MINUTES
**BOARD OF BUILDING STANDARDS/
ARCHITECTURAL BOARD OF REVIEW/SIGN REVIEW
REVIEW MEETING
CITY OF LAKEWOOD
12650 DETROIT AVENUE
AUDITORIUM
APRIL 13, 2023
5:30 P.M.
RECORDED
<https://www.lakewoodoh.gov/videos-2/>**

ARCHITECTURAL BOARD OF REVIEW

11823 Detroit Ave

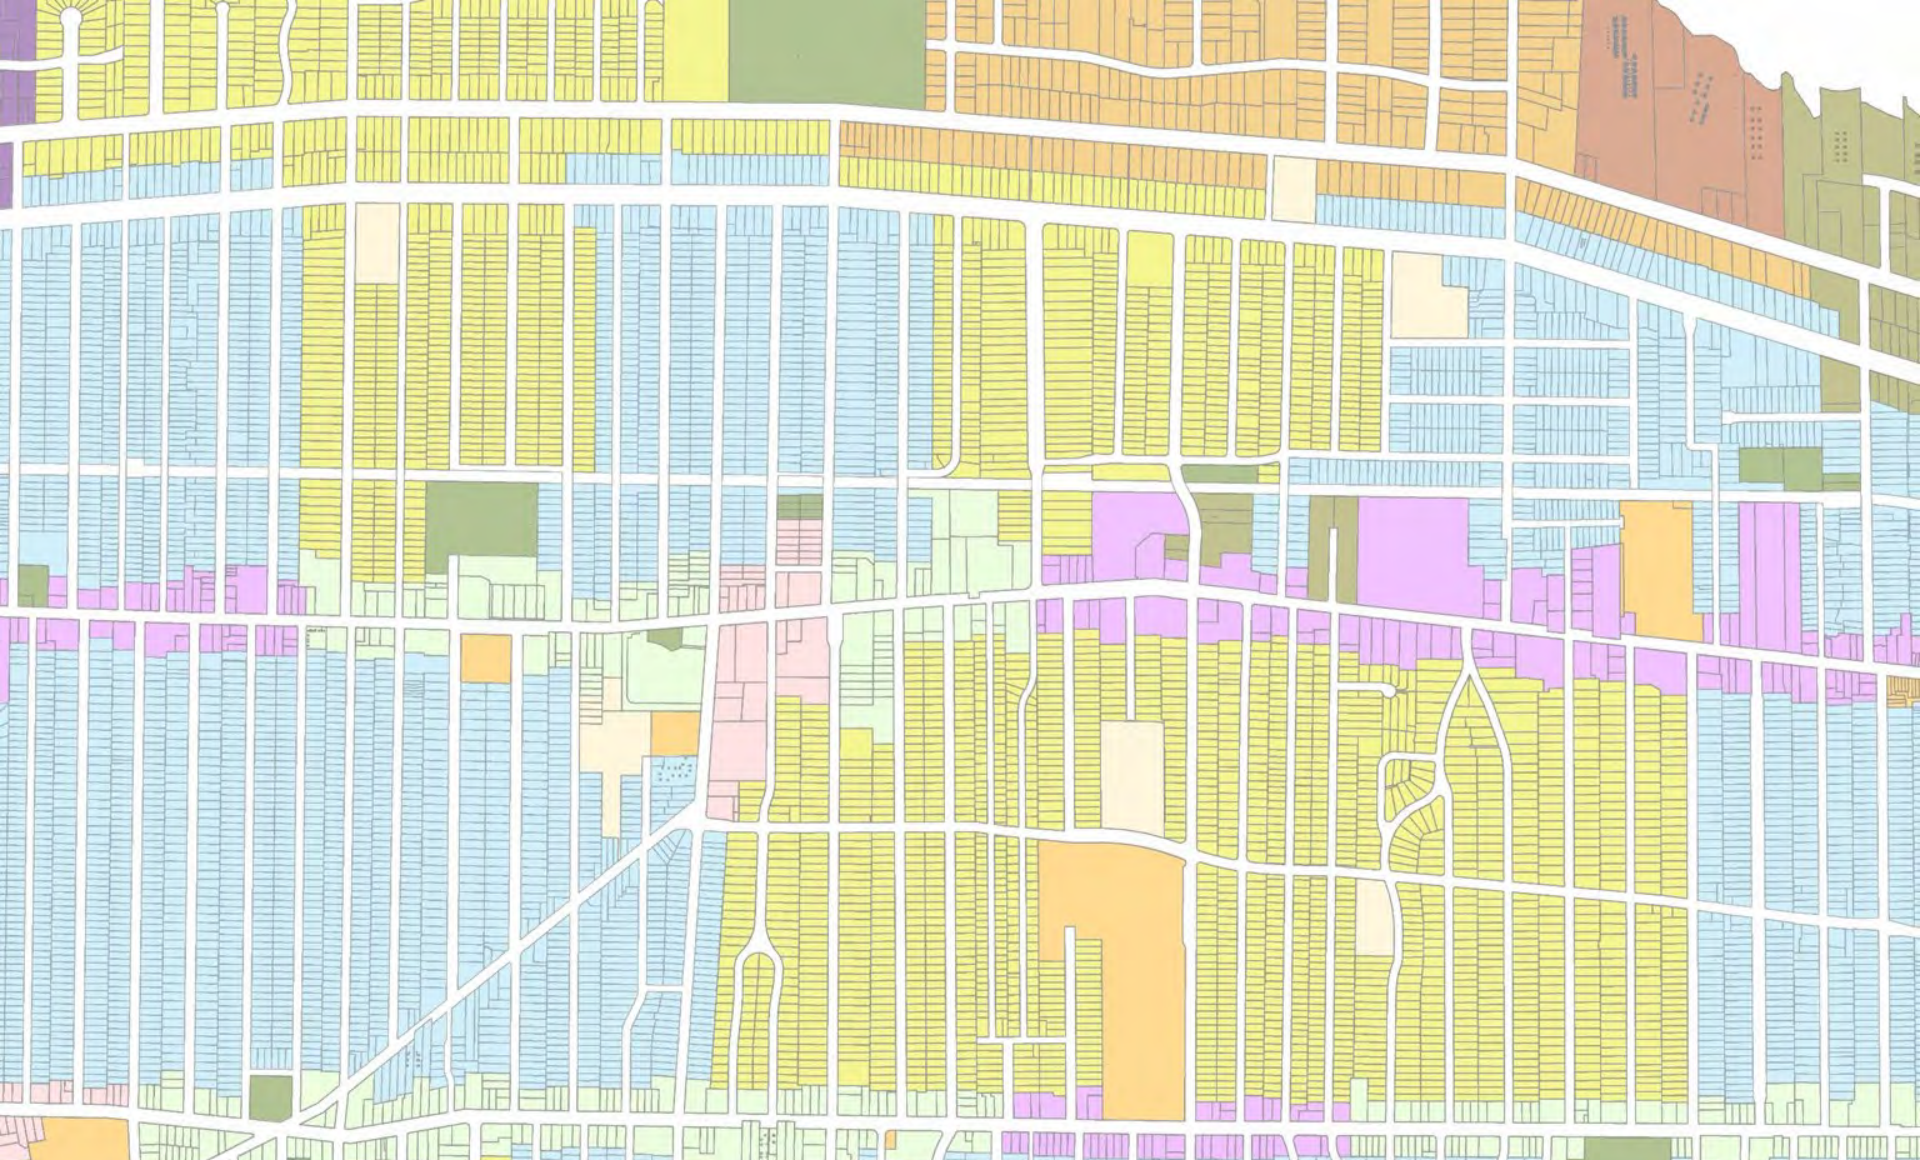
- **Raise the height/location of the mounting bracket for the projection sign so that both mounting points are in the brick portion of the façade.**

“Raise the height/location of the mounting bracket for the projection sign so that both mounting points are in the brick portion of the façade...”

Docket No. 04-31-23 (914 Beach)
 Residential New Construction

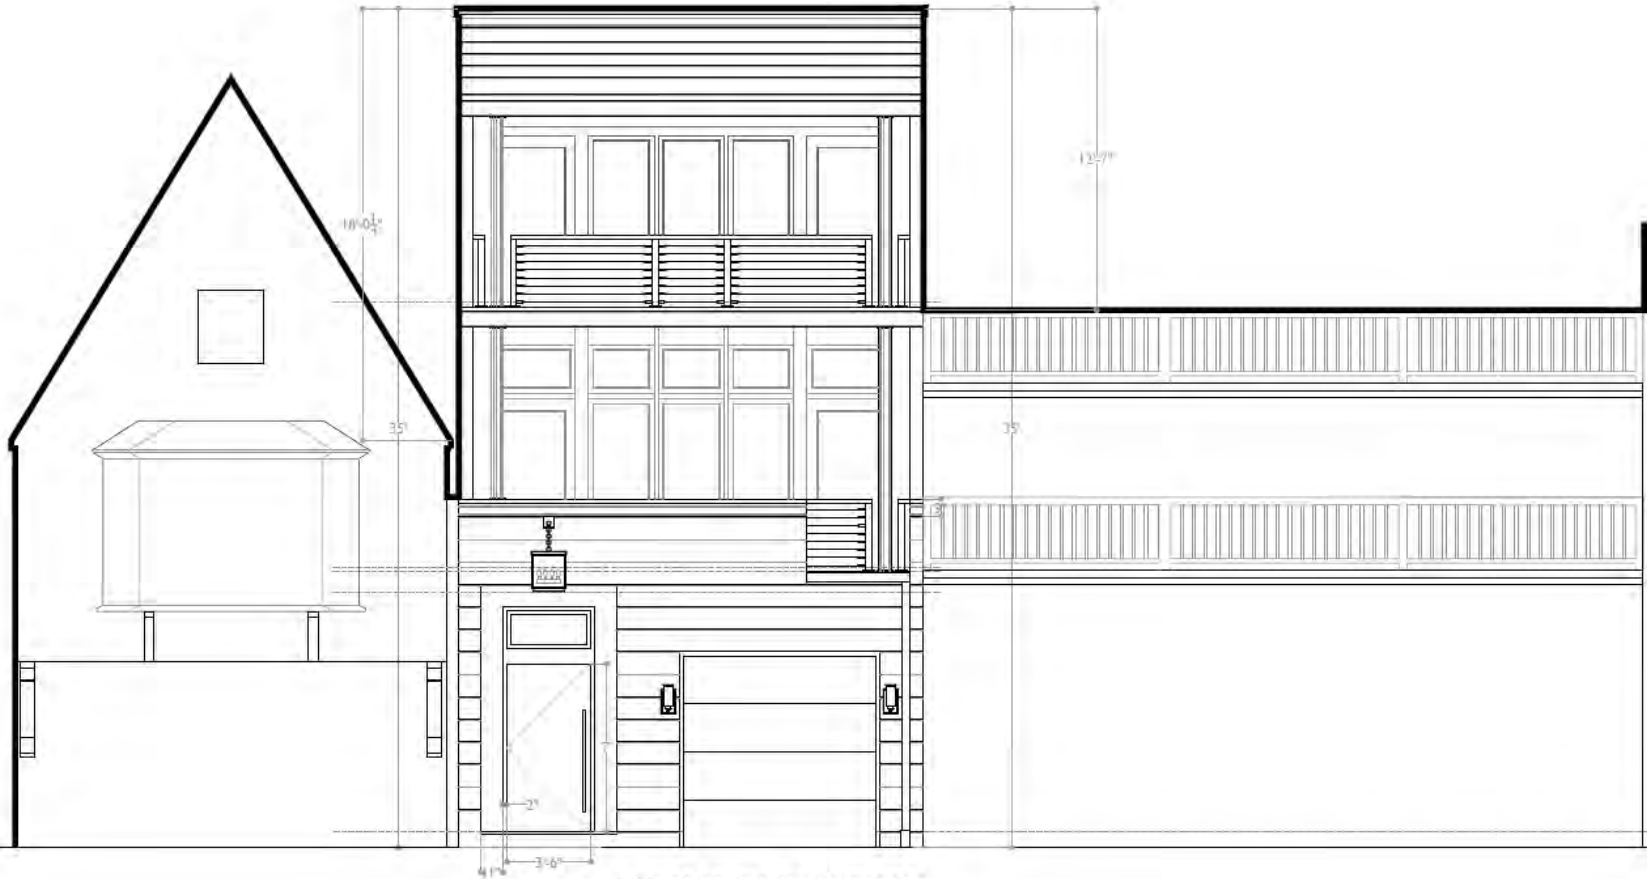
Mark H. Reinhold, Architect, applicant, and Diane Ferguson, property owner, were present to explain the request. Discussion was about the siding, rain screen system, reveals, returns, corner boards, finishes (wood, chrome, white). The members thought it was an appropriate/unique design for the eclectic area. Staff asked about fire rating. The members asked about lighting, doors, windows. Public comment was closed as no one addressed the item. Staff did not receive comments prior to the meeting.

- **The starred rendering in the packet defines the details of rain screen system returns on the building.**
- **Pending plan review by the city for permits.**
- **If there is a change to the upper-level window openings, approval could be granted administratively between the staff and the board chair, David Maniet.**

Docket No. 04-33-23 (17514 Detroit)
 Certificate of Appropriateness – St. James School

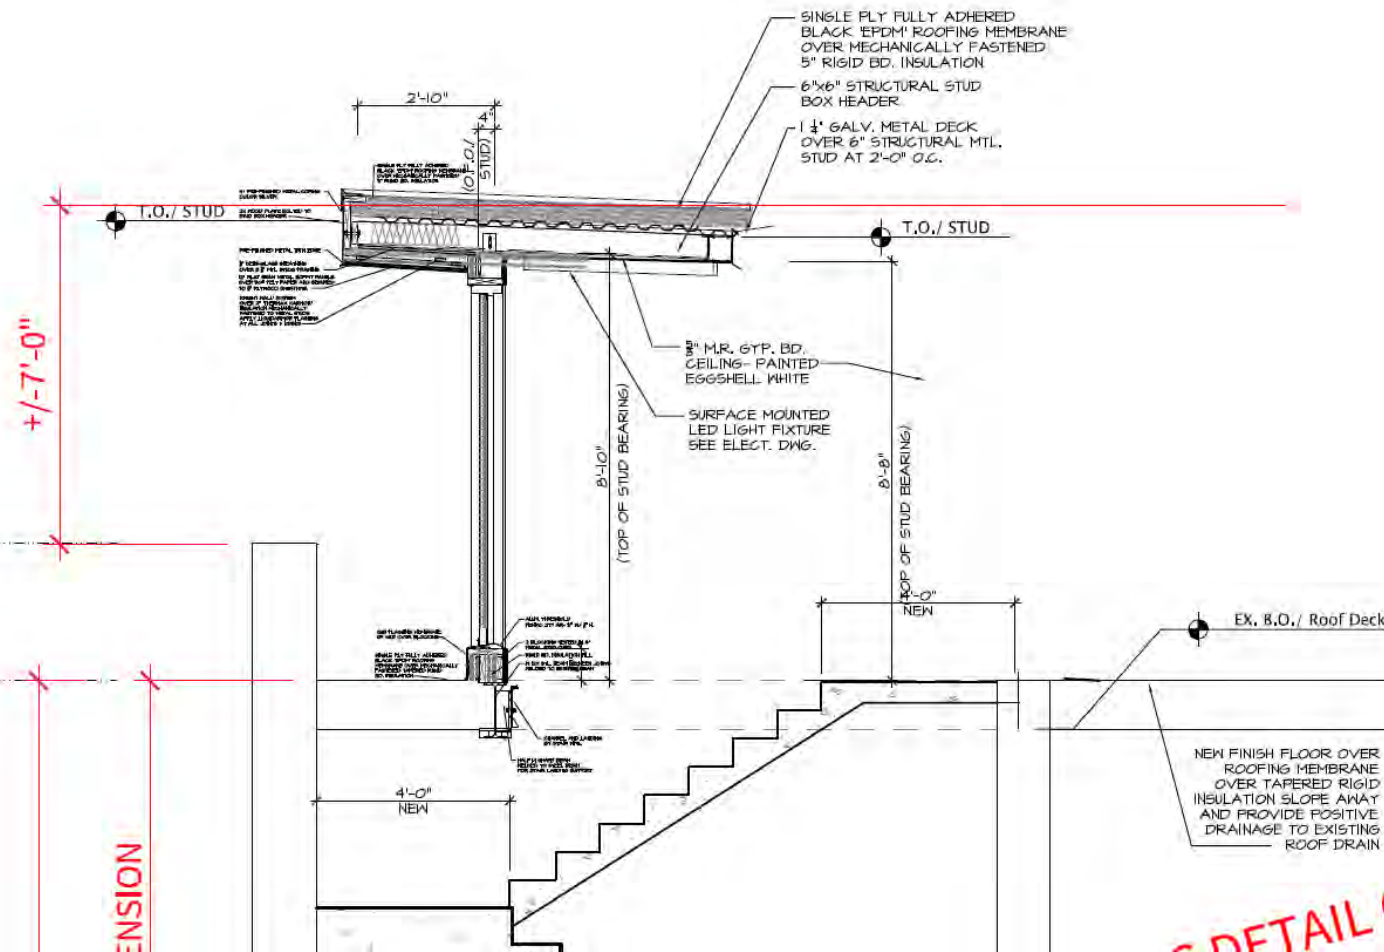
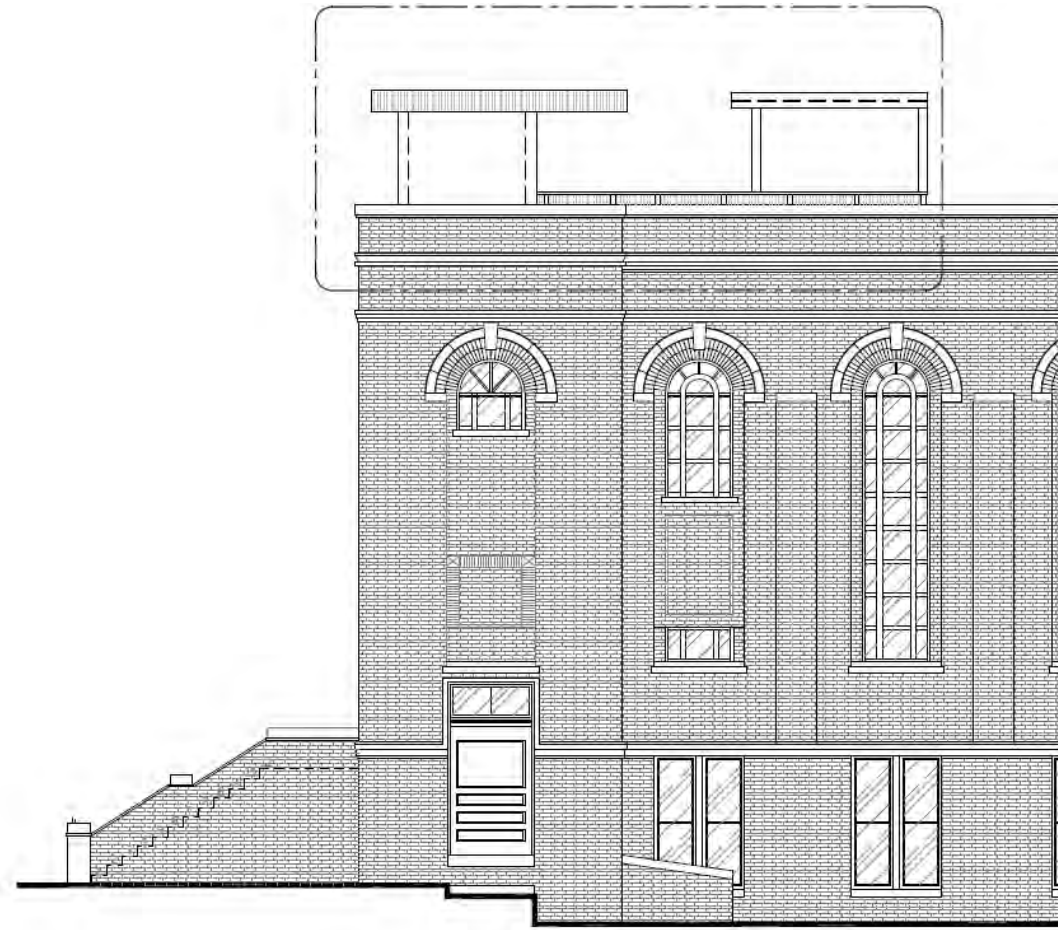
Staff provided City Notes. Gabriel Fey, HSB Architects Inc., applicant, and Jess Oster, representative of the St. James ownership group, were present to explain the request. The members liked the proposal; it was not a detriment to the historic structure. The discussion continued with colors, materials, street view, perforations, possible lighting, roof plane, the overhang looked too heavy/prominent, sandstone top cap. Staff had no comments.

- **The height of the roof plane will be changed to a taper to the end point so that the exterior fascia thickness would not exceed the height of the top sandstone cap on the existing façade of the building.**
